NED-85-693  
2124N

NRC DOCKETS 50-321, 50-366  
OPERATING LICENSES DPR-57, NPF-5  
EDWIN I. HATCH NUCLEAR PLANT UNITS 1, 2  
REACTOR WATER LEVEL INSTRUMENTATION IN BWRs  
(GENERIC LETTER 84-23)

EDWIN I. HATCH NUCLEAR PLANT UNITS 1 AND 2  
ADDITIONAL INFORMATION IN RESPONSE TO  
GENERIC LETTER 84-23  
REACTOR WATER LEVEL INSTRUMENTATION IN BWRS

FIGURE 1  
 IRYWELL COMPOSITE PLANNING DRAWING  
 UNIT NO 2 — PLAN EL 162.0 TO EL 135.0  
 DRAWN BY BOUNSALL WILLIAMS LTD 85-7-77  
 CHECKED BY 30-1-77

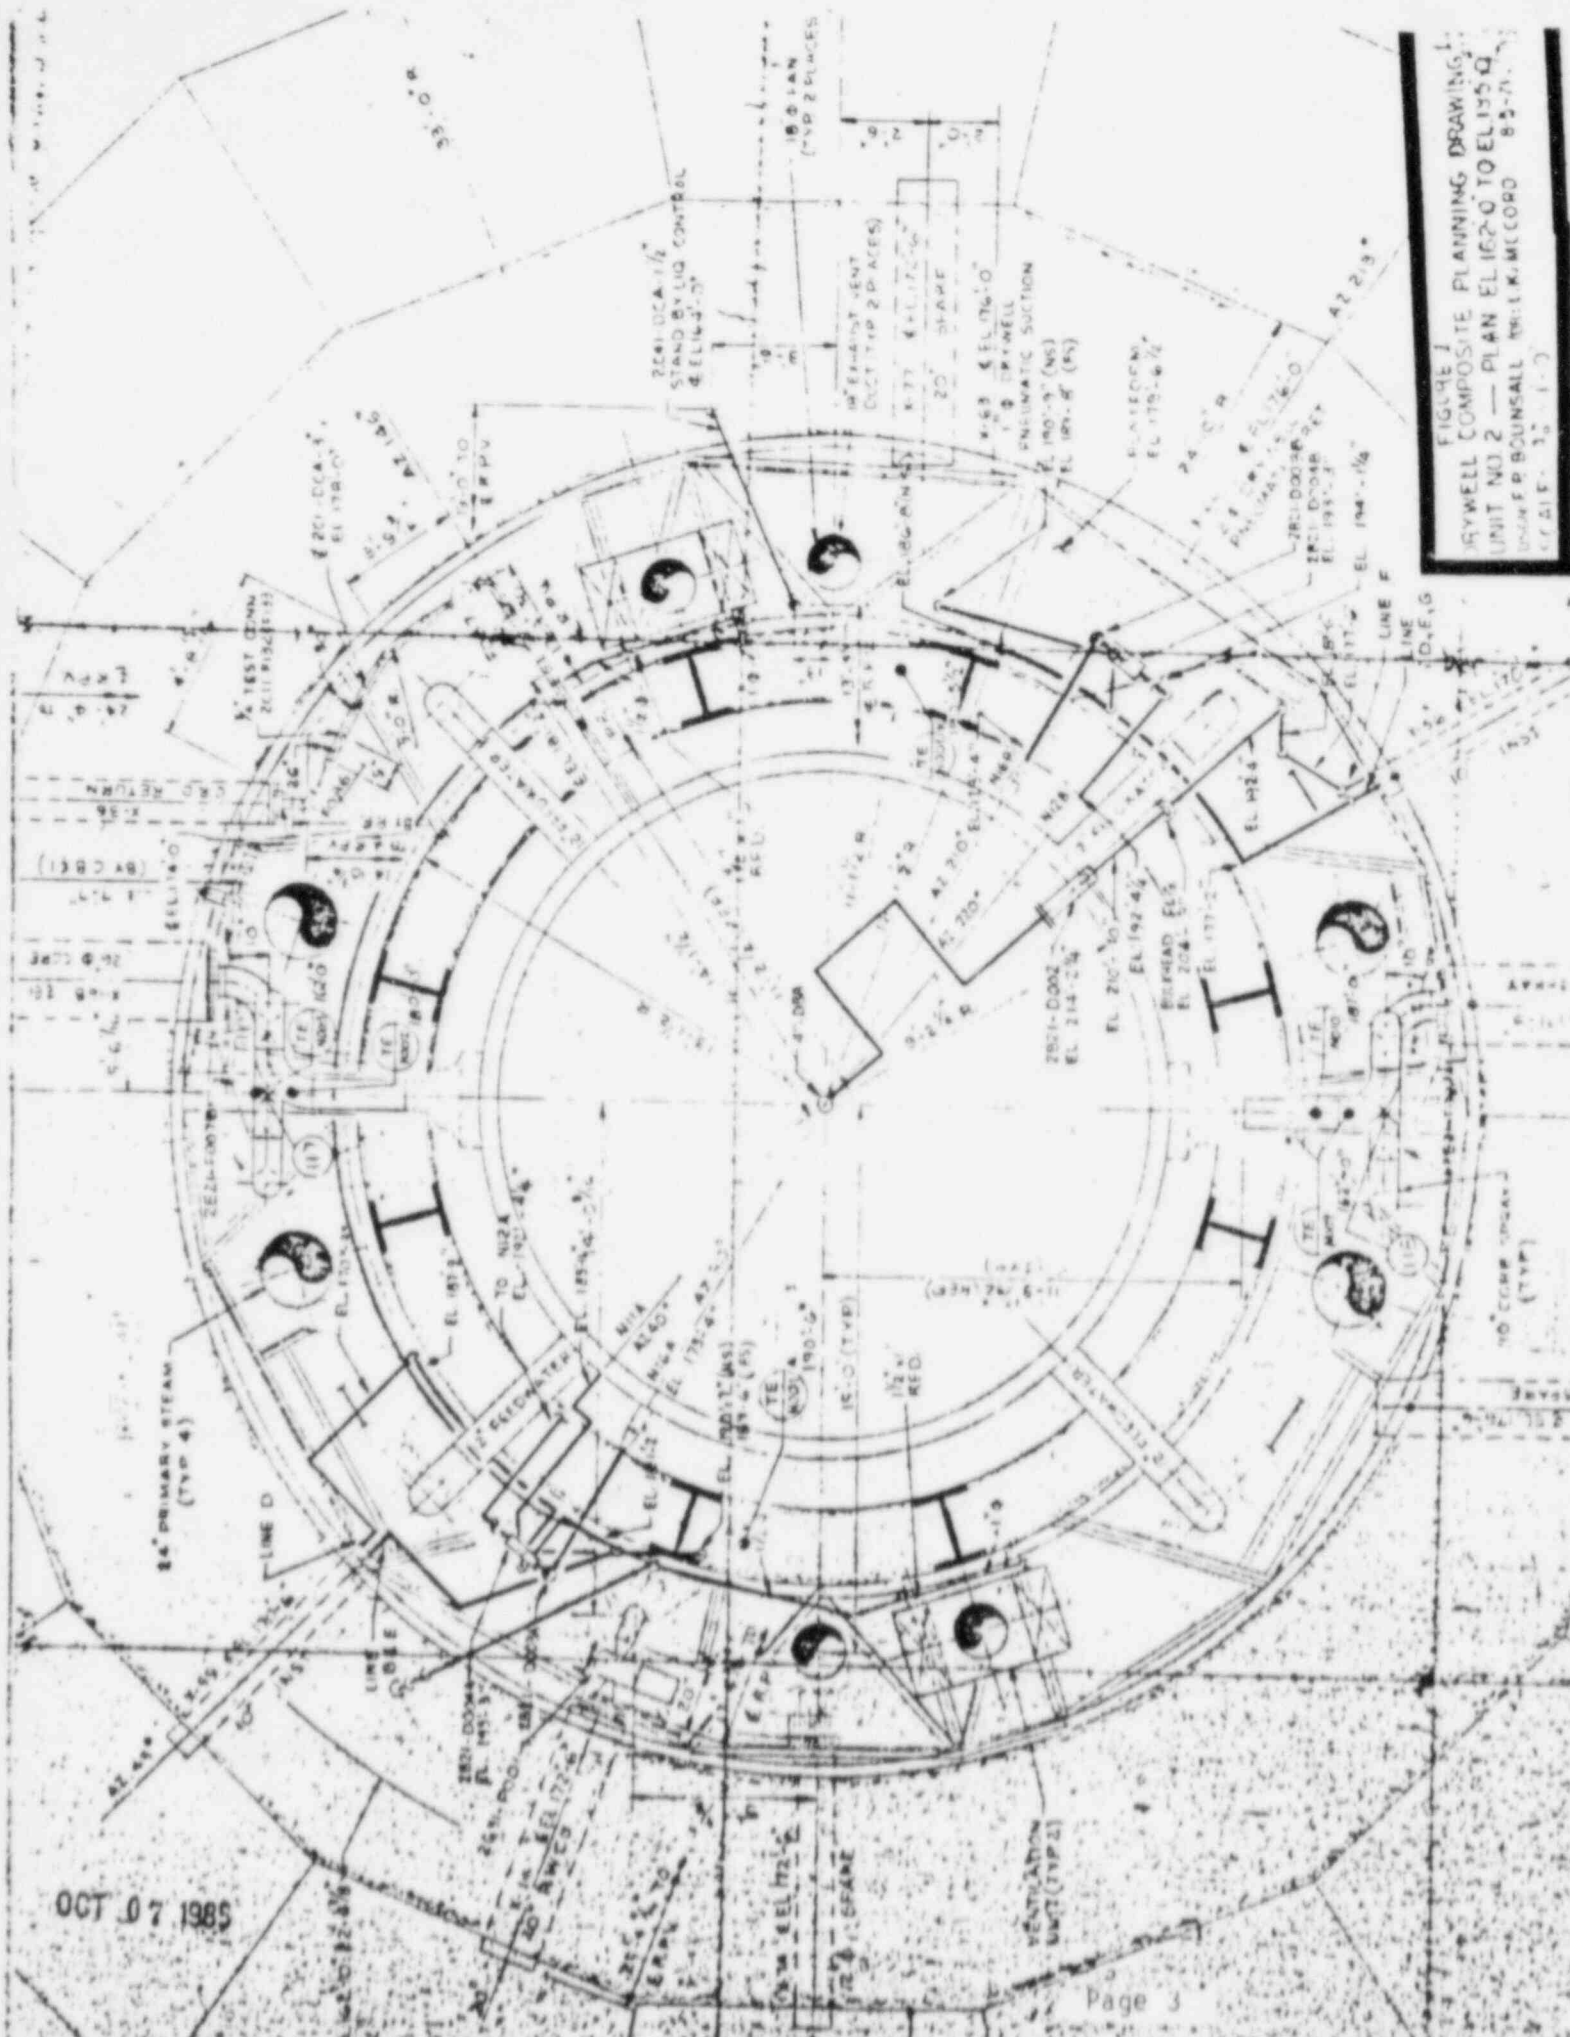
GPC was requested to provide justification that the instrument line temperature used in the SPDS density compensation is representative of the entire line, i.e., could a hot spot in an instrument line cause erroneous compensation?

Figures 1 and 2 show the positions of these RTDs relative to the level instrument lines and other equipment in the drywell. The average drywell temperature  $T_D$  used in the SPDS density compensation is calculated as:

The Unit 1 RTDs will be relocated closer to the reference columns during the fall 1985 refueling outage. The Unit 2 RTDs have already been relocated. A review was performed to assess air temperature variations in the upper cylindrical portion of the drywell, where the level instrument reference columns are located. This review addressed:

Heat sources affecting this area are the feedwater and main steam lines (See Figures 1 and 2). Since the feedwater lines are equally spaced around the annulus between the drywell shell and the shield wall, their temperature contribution is fairly uniform. The main steam lines are arranged with two lines in each of two opposite quadrants, and none in the remaining quadrants. Since the reference columns are located in the quadrants having no main steam lines, they are not subject to localized heating.

FIGURE 3

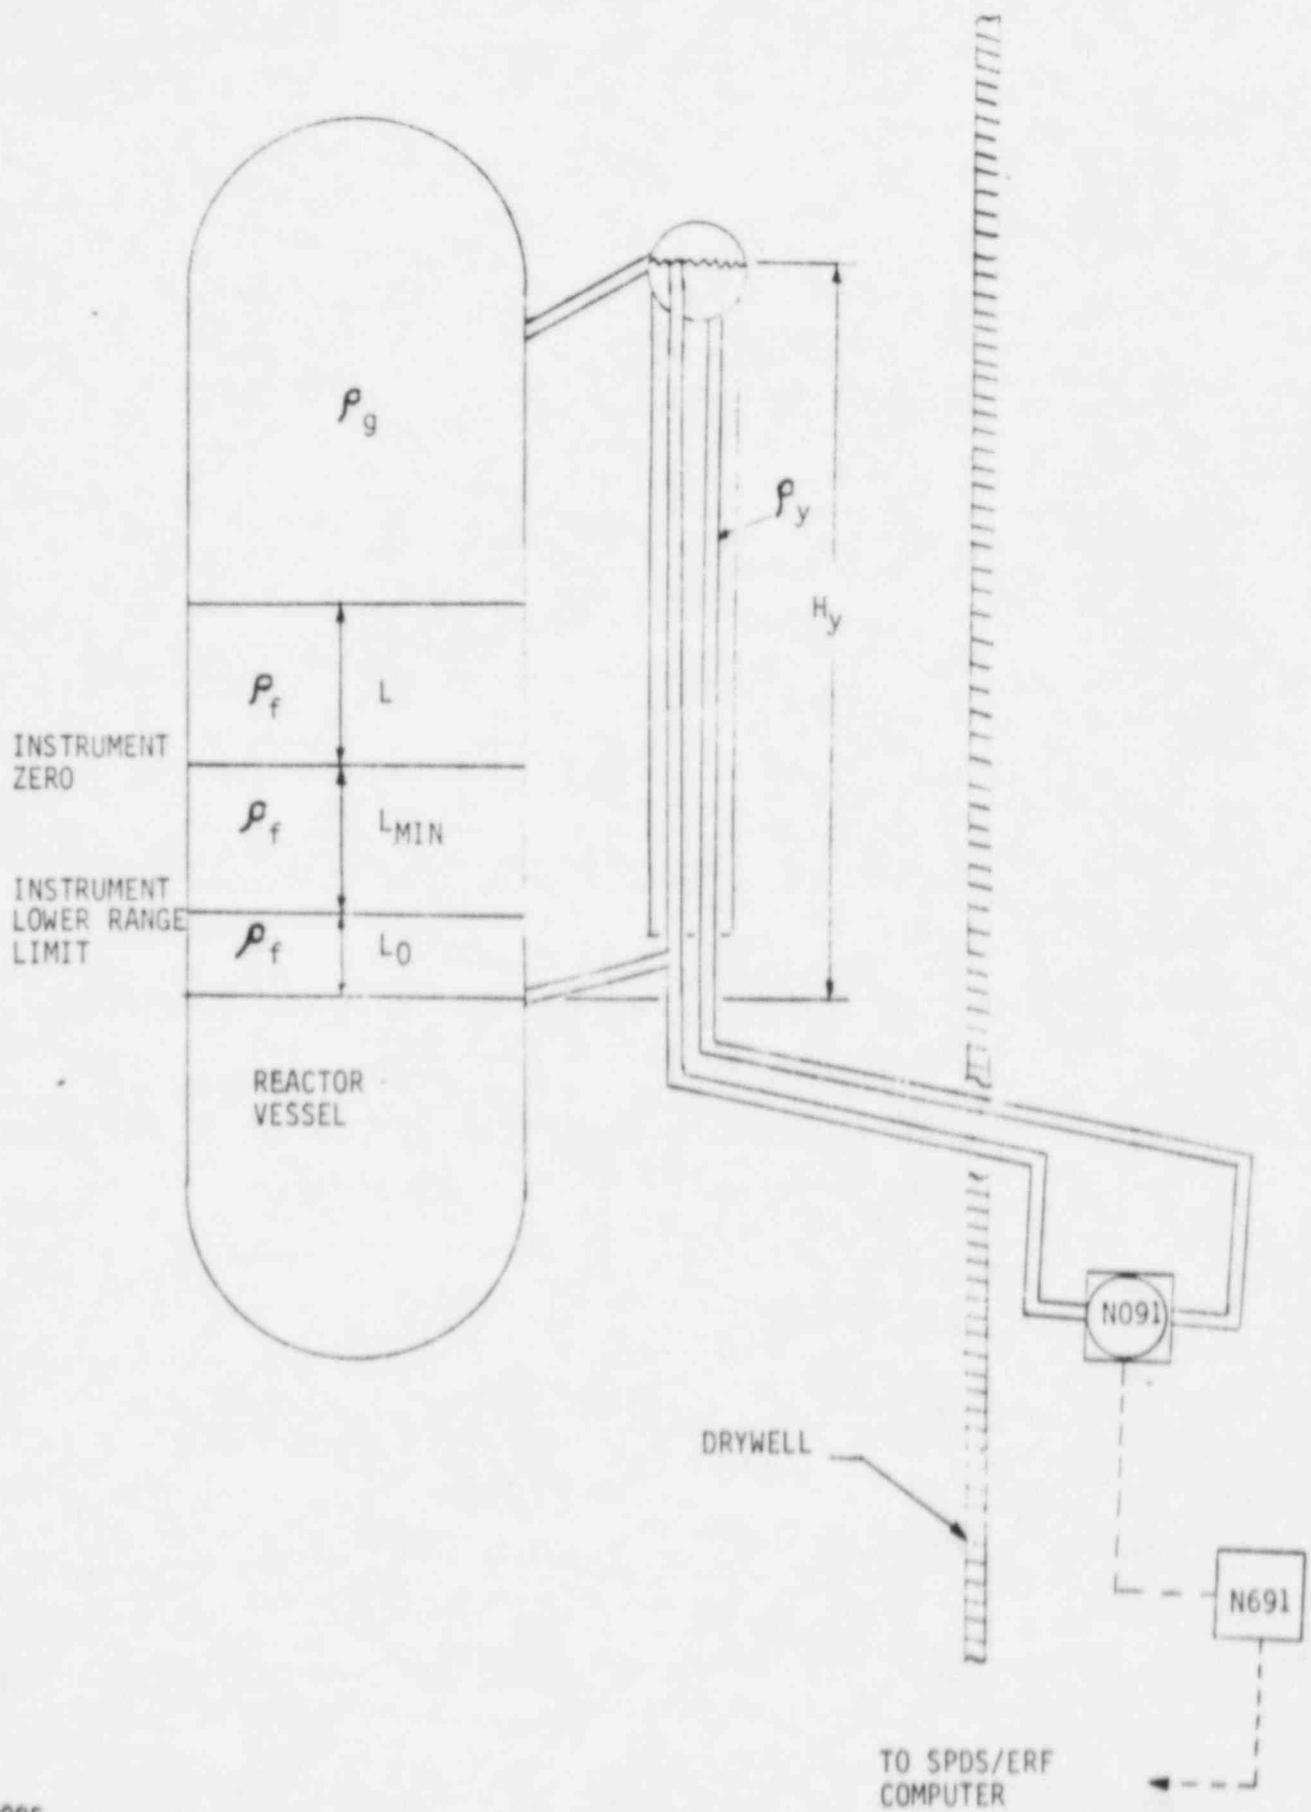
GPC was requested to provide a detailed explanation of the logic used by the SPDS to correct reactor water level readings for drywell heatup.

Using the variables defined in Figure 3, the equation for actual reactor water level is determined by equating the pressure differential sensed by the level transmitter to that of the indicated level at calibration conditions:

$$L_A = (\rho_{fc} - \rho_{fg}) / (\rho_f - \rho_g) [L_I + L_{MIN} + L_0 + H_y(\rho_y - \rho_g - \rho_{yc} + \rho_{gc}) / (\rho_{fc} - \rho_{gc})] - L_{MIN} - L_0 \quad (Eq. 2)$$

$$T_y = T_D + 0.4 (T_R - T_D) \quad (Eq. 3)$$
